SERVICE BULLETIN

N° 139-615

ATA 00 – INSTALLATION OF SPECIFIC VARIANTS FOR OFFSHORE CONFIGURATION

This Service Bulletin is issued in order to provide the necessary instructions to perform the installation of some modifications required by the Customer to align the configuration of its fleet.

Figure 10

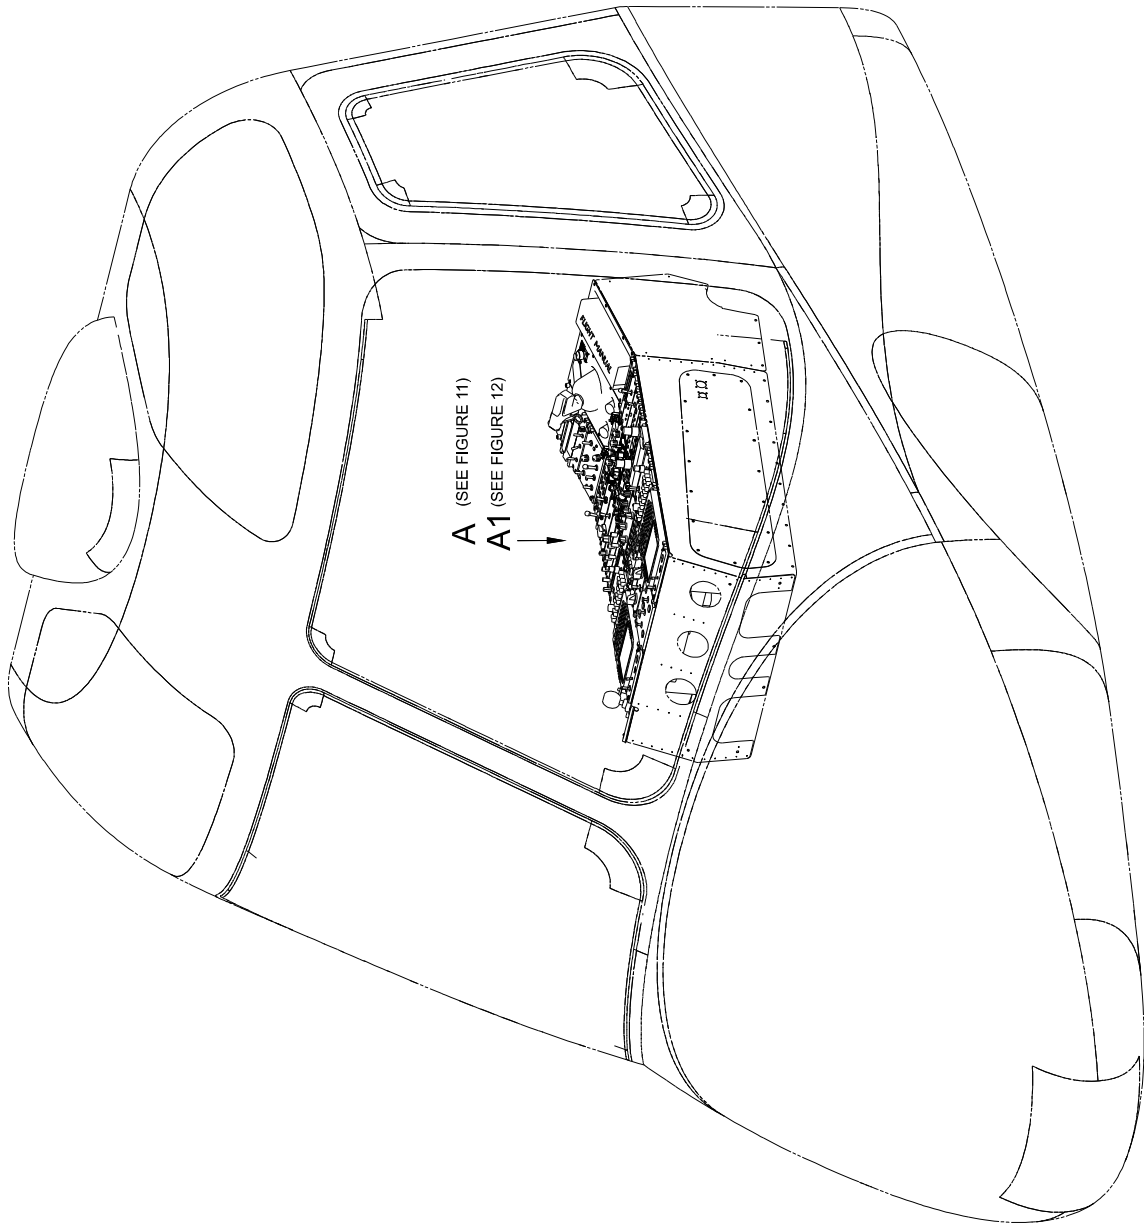
Part II provides all necessary instructions to perform the interseat console variant P/N 3G0630P19411. The light and landing control panel is moved on the right side of the inter-seat console. The pocket for the QRH is installed on the left side of the inter-seat console.

Figure 11

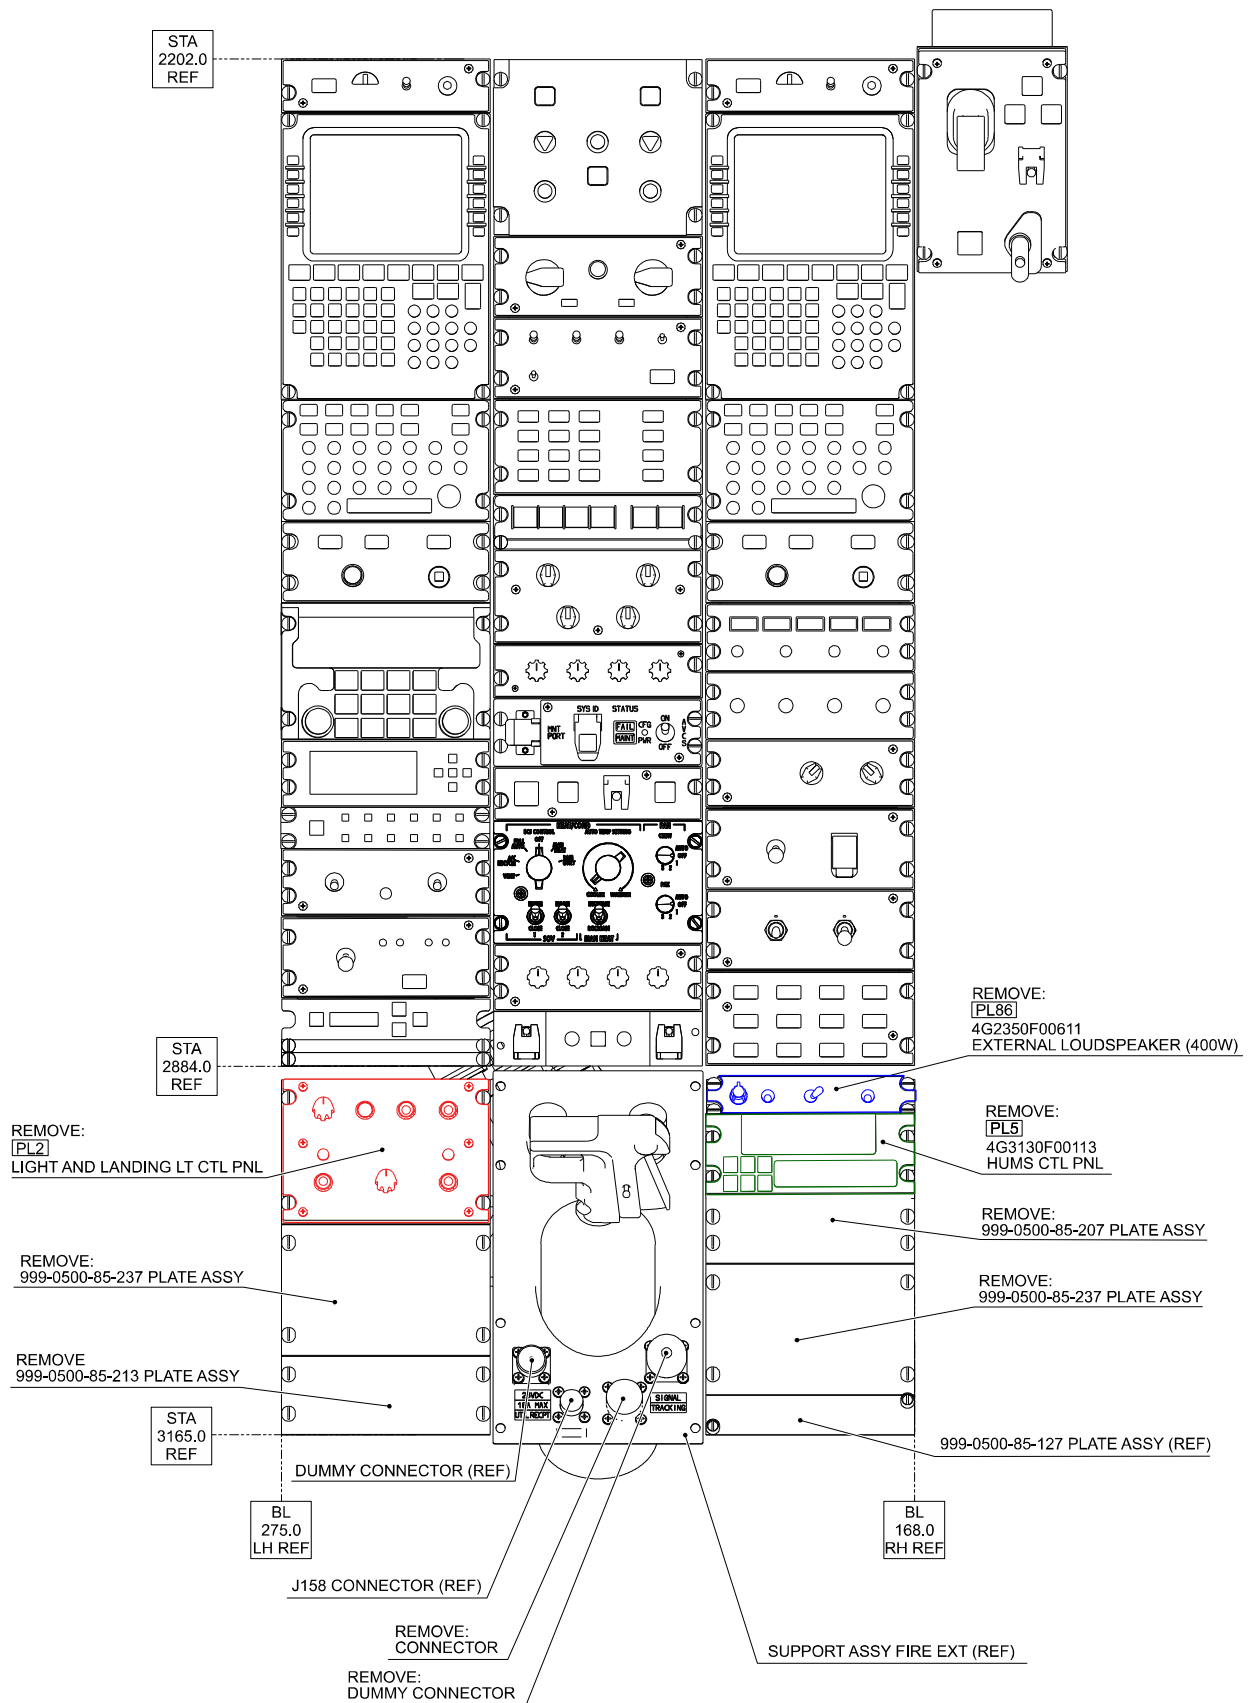
- 2.1 With reference to Figure 11 view A and in accordance with applicable steps of AMP DM 39-C-33-43-01-00A-520A-K remove the light and landing LT control panel PL2 and retain existing hardware for later reuse.

- 2.2 With reference to Figure 11 View A, remove the plate assy P/N 999-0500-85-237 from the LH side of the interseat console.
 - 2.3 With reference to Figure 11 View A, remove the plate assy P/N 999-0500-85-213 from the LH side of the interseat console.

- 2.5 With reference to Figure 11 View A and in accordance with the applicable steps of AMP DM 39-A-23-33-01-00A-520A-K remove the external loudspeaker (400W) P/N 4G2350F00611.

- 2.6 With reference to Figure 11 View A and in accordance with the applicable steps of AMP DM 39-A-31-32-02-00A-520A-K remove the HUMS control panel P/N 4G3130F00113.

- 2.7 With reference to Figure 11 View A, remove the plate assy P/N 999-0500-85-207 from the RH side of the interseat console.
 - 2.8 With reference to Figure 11 View A, remove the plate assy P/N 999-0500-85-237 from the RH side of the interseat console.

Figure 12

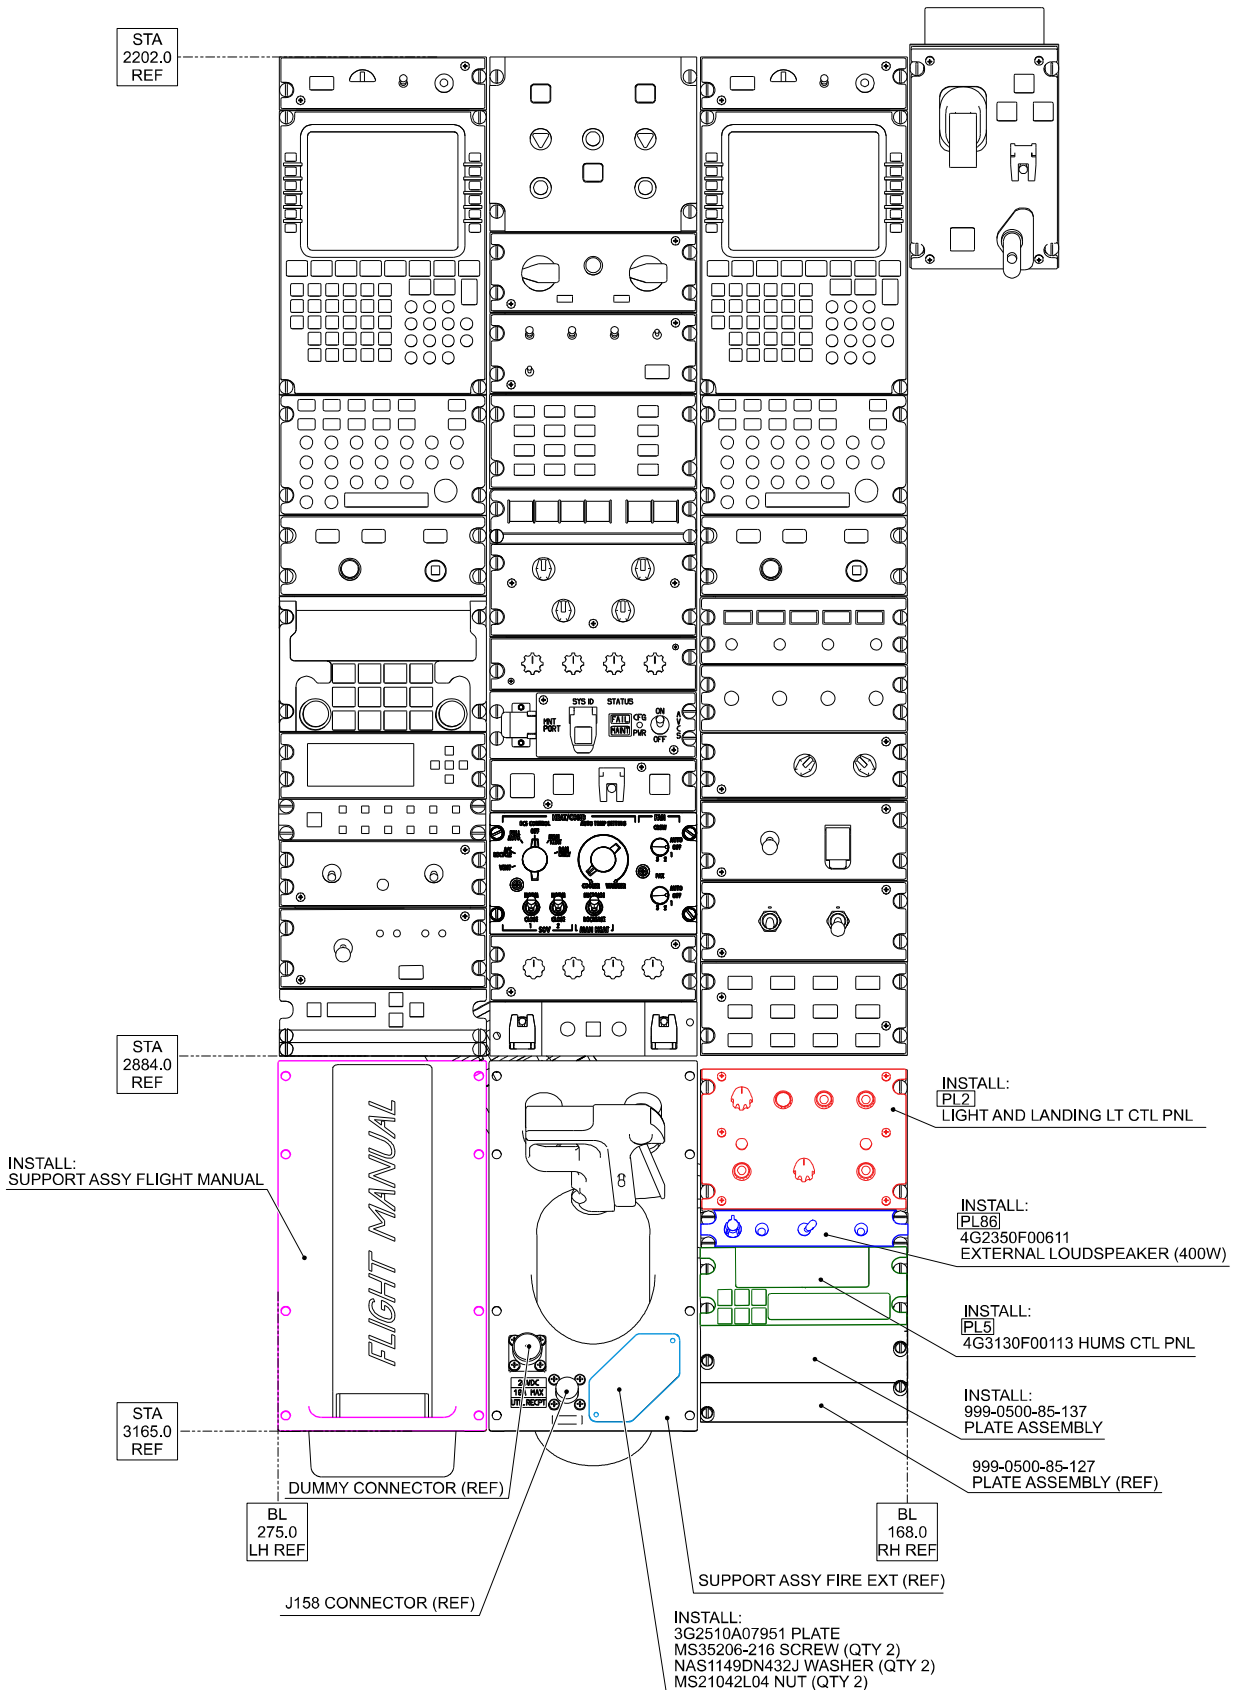
- 2.4 With reference to Figure 12 View A1 and in accordance with applicable steps of AMP DM 39-A-25-16-01-00A-720A-K install the support assy flight manual P/N 3G2510A05051.

- 2.9 With reference to Figure 12 View A1 and in accordance with the applicable steps of AMP DM 39-C-33-43-01-00A-720A-K install the light and landing LT control panel PL2.

- 2.10 With reference to Figure 12 View A1 and in accordance with the applicable steps of AMP DM 39-A-23-33-01-00A-720A-K install the external loudspeaker (400W) P/N 4G2350F00611.

- 2.11 With reference to Figure 12 View A1 and in accordance with the applicable steps of AMP DM 39-A-31-32-02-00A-720A-K install the HUMS control panel P/N 4G3130F00113.

- 2.12 With reference to Figure 12 View A1 install the plate assembly

- 2.13 With reference to Figure 11 View A remove the dummy connector.
 - 2.14 With reference to Figure 11 View A remove the connector.
 - 2.15 With reference to Figure 12 View A1 install the cover P/N 3G2510A07952 by means of n°2 screws P/N MS35206-216, n°2 washers P/N NAS1149DN432J and n°2 nuts P/N MS21042L04.
3. Return the helicopter to flight configuration and record for compliance with Part II of this Service Bulletin on the helicopter logbook.
 4. Send the attached compliance form to the following mail box:

Figure 13

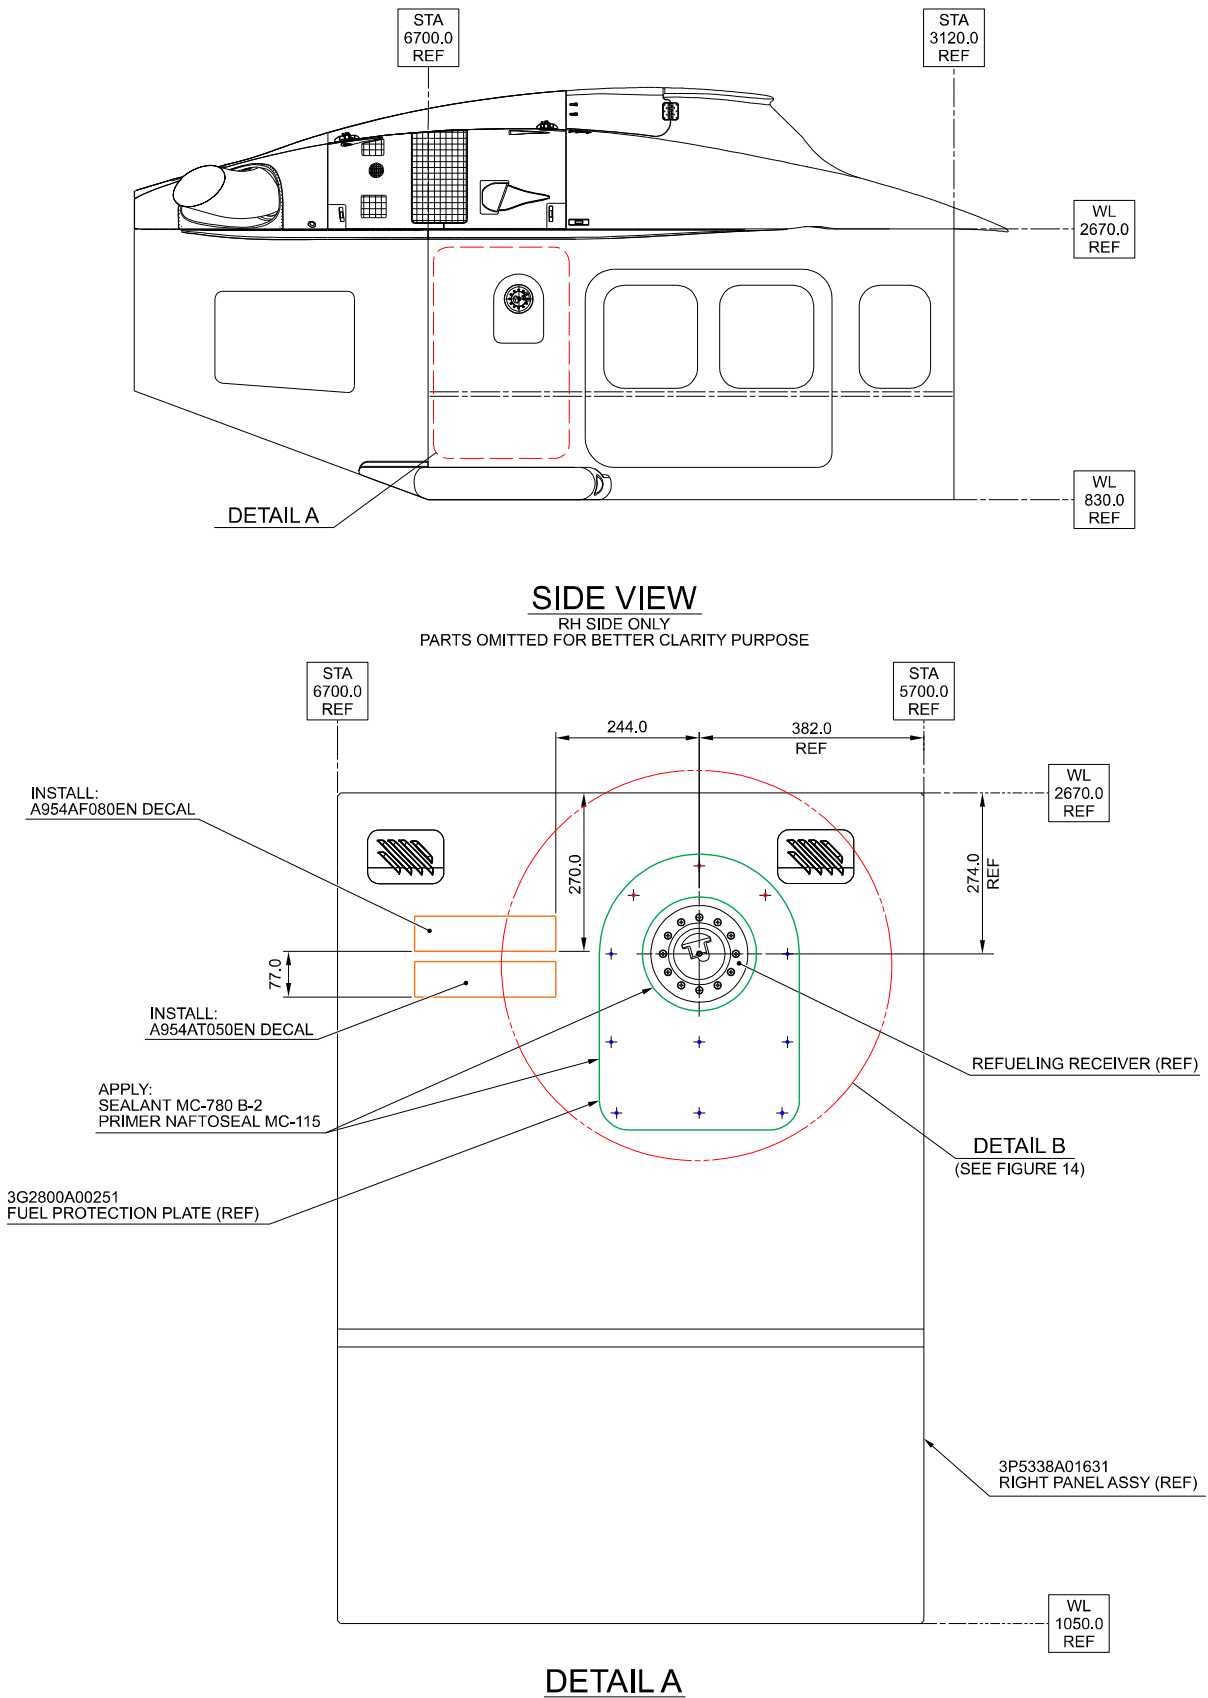
- 2.2 With reference to Figure 13 Detail A, temporarily locate the fuel protection plate P/N 3G2800A00251 and countermark the edges of the fuel protection plate P/N 3G2800A00251 on right panel assy P/N 3P5338A01631.

- 2.5 With reference to Figure 14 Detail B and Section C-C, fix the fuel protection plate P/N 3G2800A00251 on right panel assy P/N 3P5338A01631 by means of n°3 rivets P/N NAS9301B-4-03 and n°8 rivets P/N NAS9301B-4-01 in accordance with the dimensioning shown.
- 2.6 With reference to Figure 13 Detail A, apply sealant MC-780 B-2, Ty I, Cl B, Gr 2 and Primer Naftoseal MC-115 on the indicated contour.

- 2.7 With reference to Figure 13 Detail A and in accordance with AMP DM 39-A-11-00-01-00A-720A-A, install the decal P/N A954AF080EN and decal P/N A954AT050EN on the right panel assy P/N 3P5338A01631 in accordance with the dimensioning shown.
3. Return the helicopter to flight configuration and record for compliance with Part III of this Service Bulletin on the helicopter logbook.
4. Send the attached compliance form to the following mail box:

Figure 14

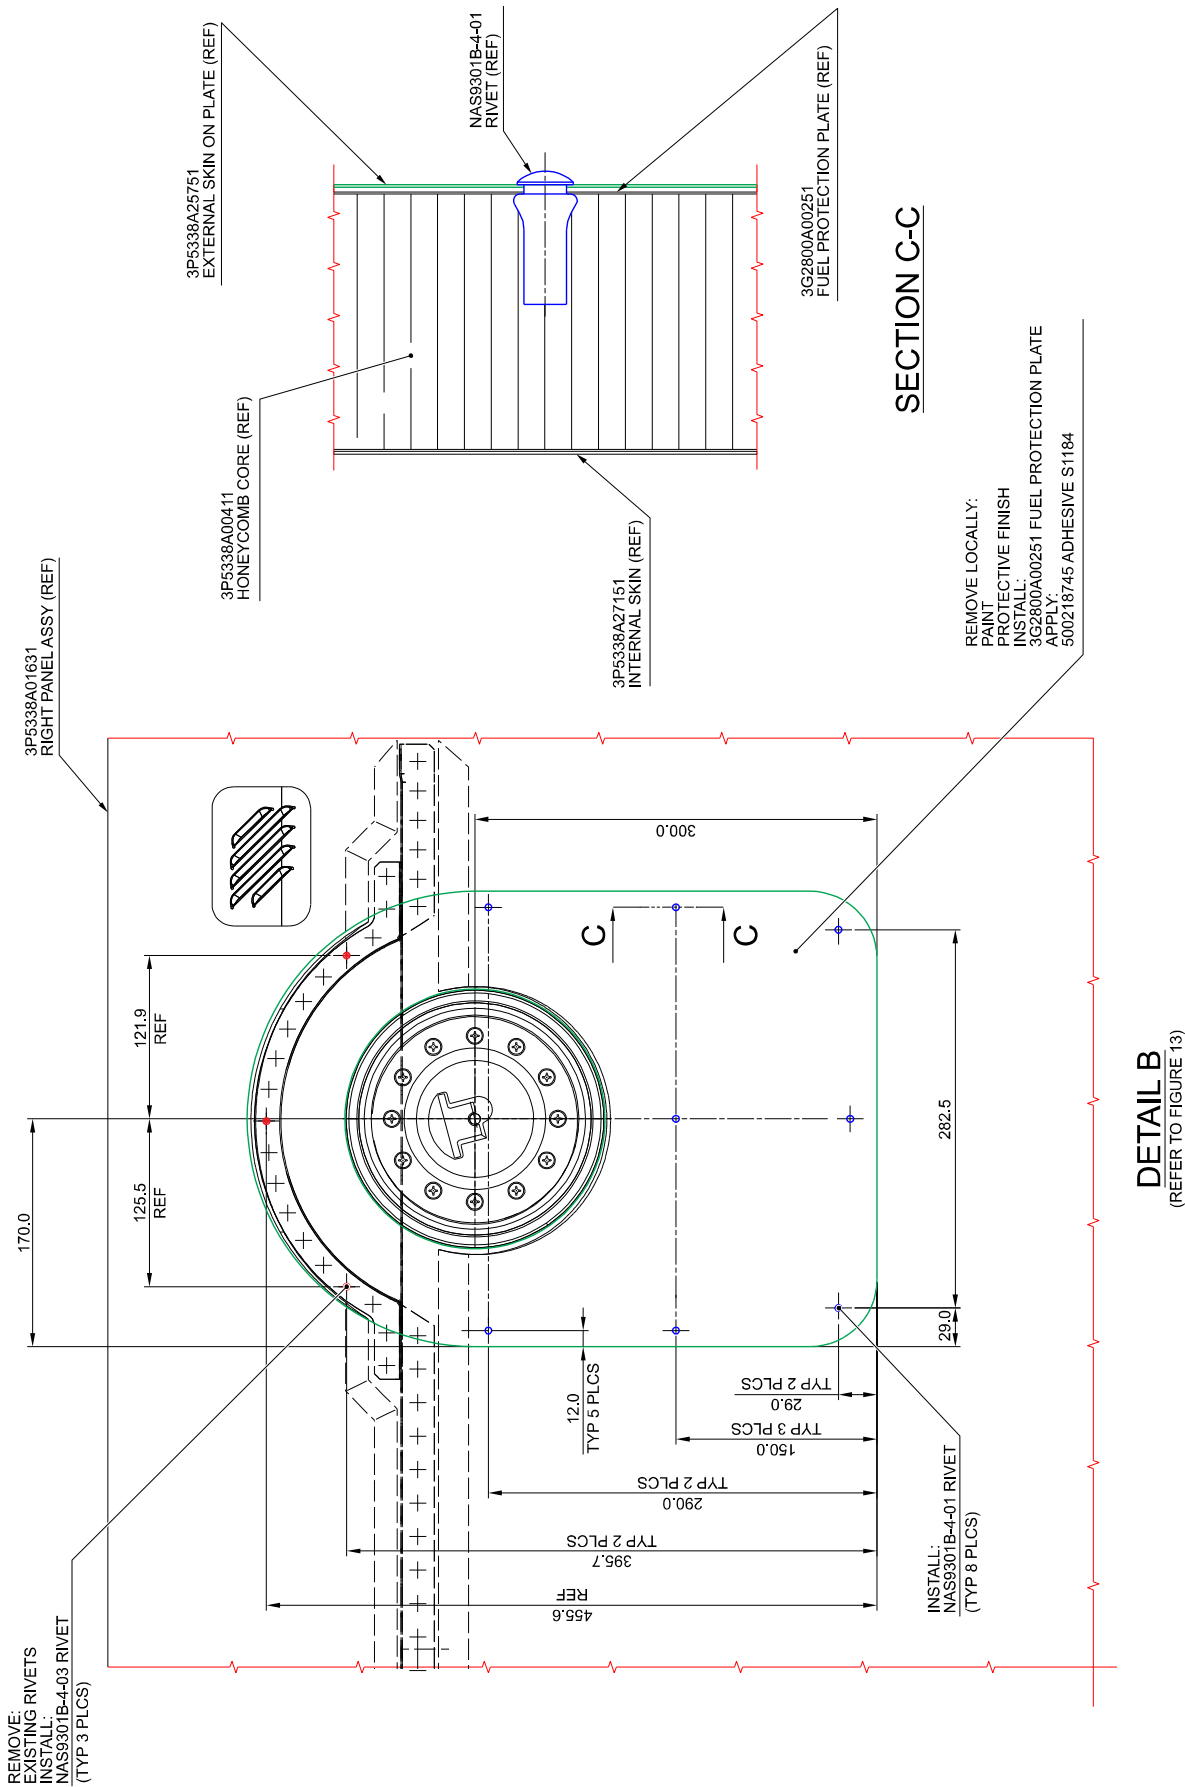
2. With reference to Figures 13 and 14, perform the fuel protection plate installation P/N 3G2800A00711 as described in the following procedure:
 - 2.1 With reference to Figure 14 Detail B, remove n°3 existing rivets from the right panel assy P/N 3P5338A01631 in accordance with the position shown.
